**Technical Service
BULLETIN**

PARKING BRAKE CLICK NOISE

'06 RAV4

**BRAKES
BR003-06**

Components

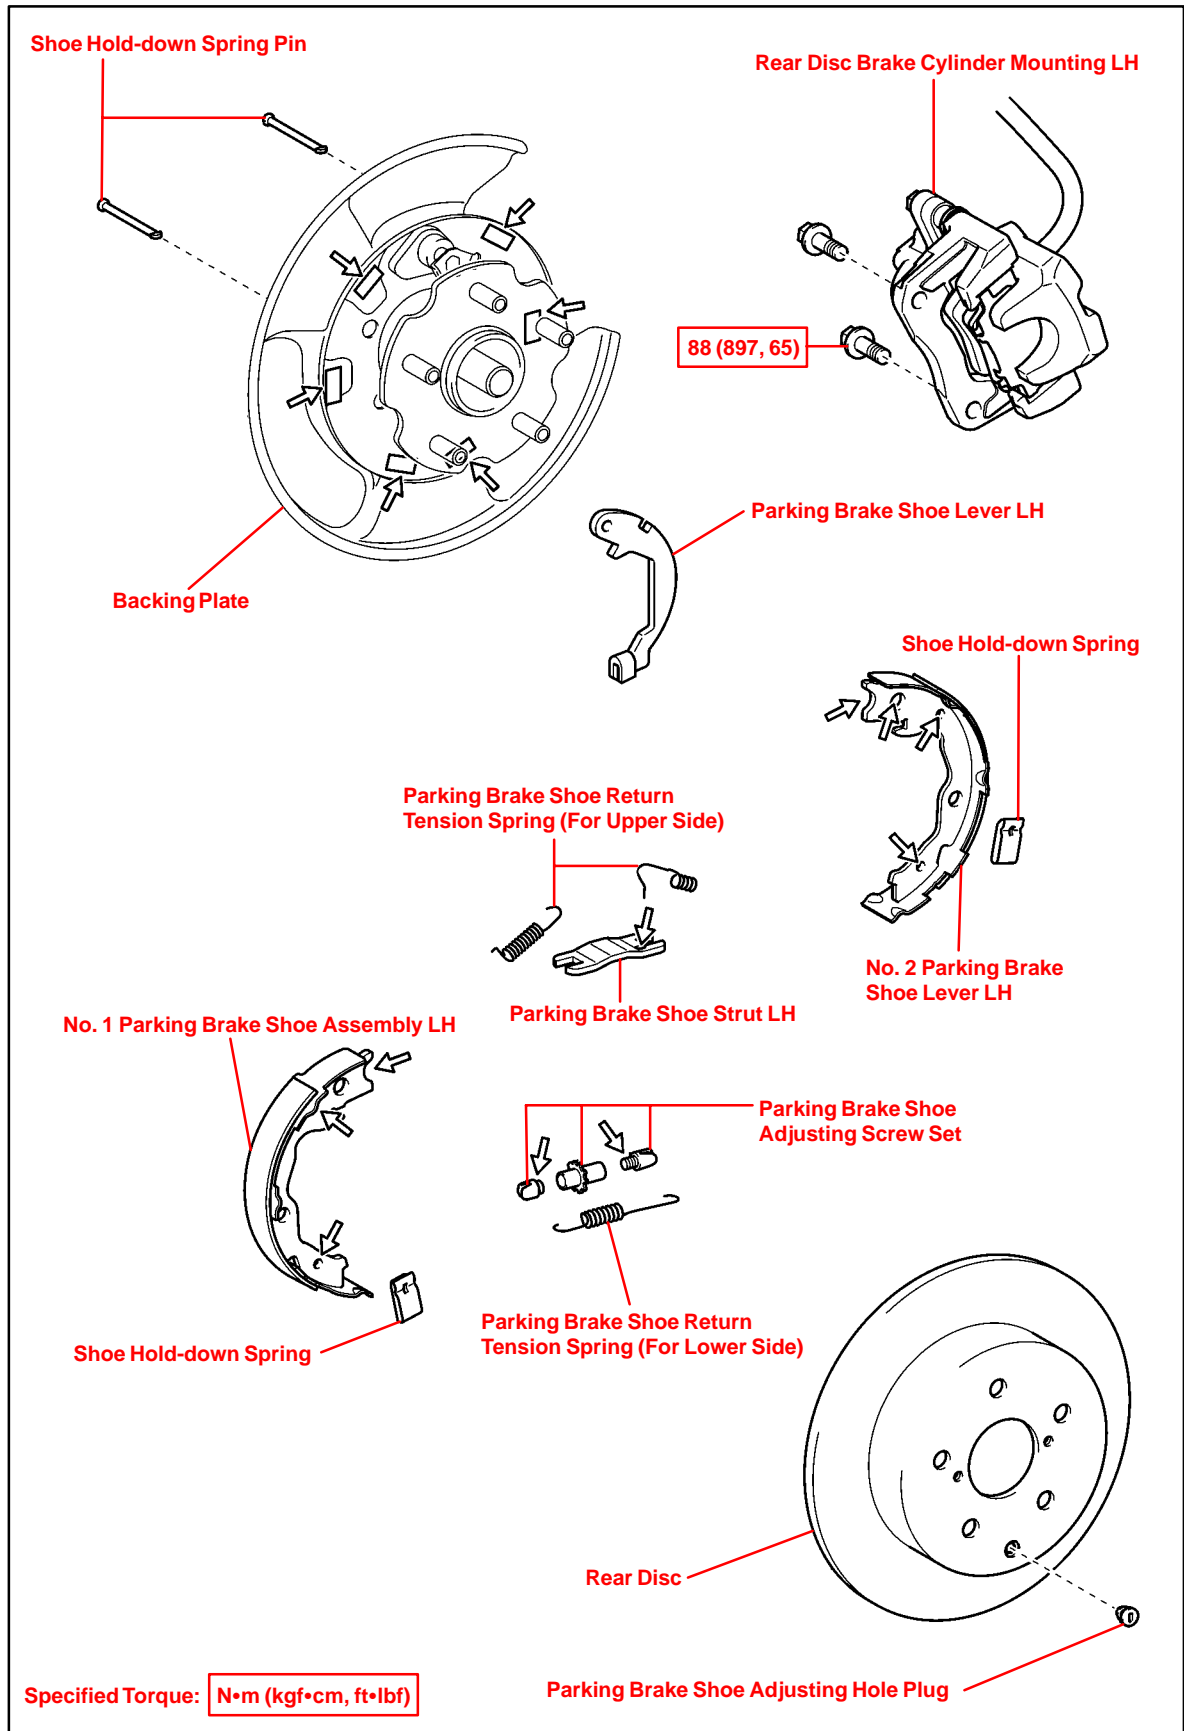
Introduction Some customers may experience a click noise coming from the left rear brake area when utilizing the parking brake hand lever. Updated parking brake shoe lever service parts are available to improve the noise condition.

PREVIOUS PART NUMBER	CURRENT PART NUMBER	PART NAME	QTY
46602-42040	Same	Lever, Parking Brake Shoe, LH	1

1. Operate the parking brake lever several times and listen for a click noise coming from the left rear brake area.
2. Remove and replace the left rear Parking Brake Shoe Lever (P/N: 46602–42040) by following the procedures in the Technical Information System (TIS):
